Addendum D4

re: **City of Berne**
New Municipal Maintenance Building
 335003.00

date: **March 1, 2024**

UTILITY PLAN

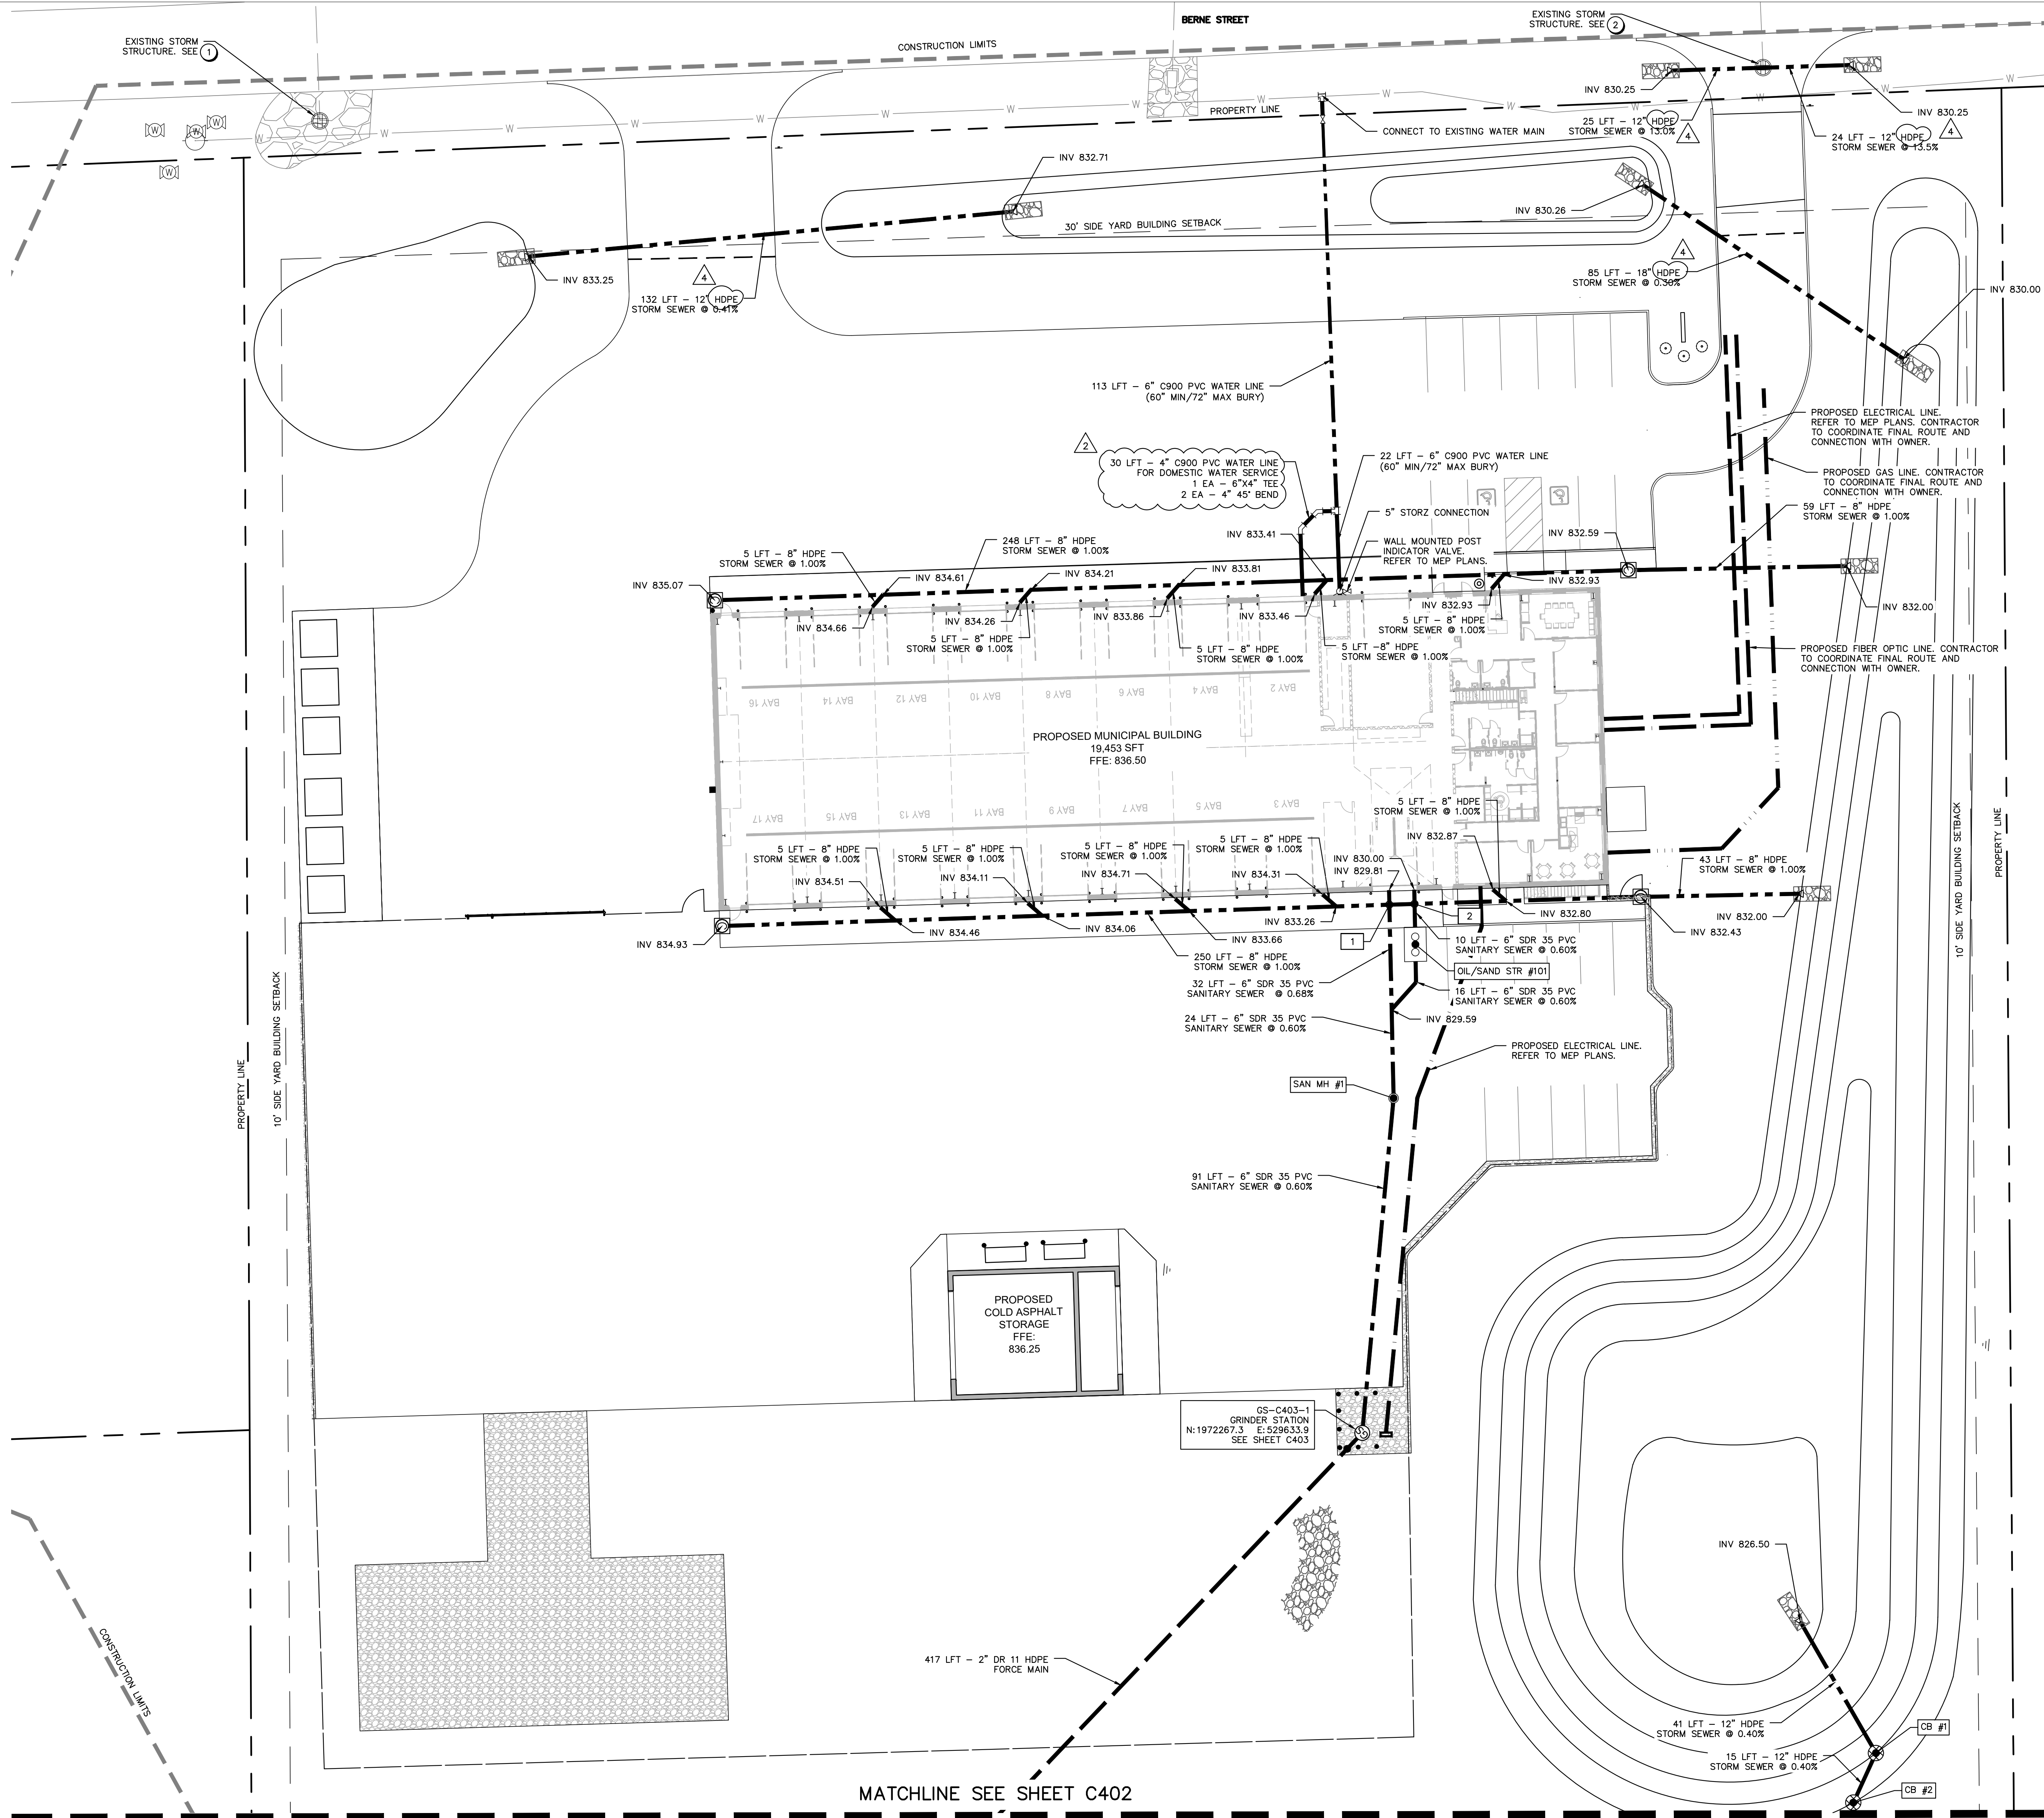
C4.03	DRAWING C401 (<i>Drawing Reissued</i>)	<p><u>REVISED:</u></p> <p>REVISE Pipe material type of new RCP storm pipes to HDPE.</p>
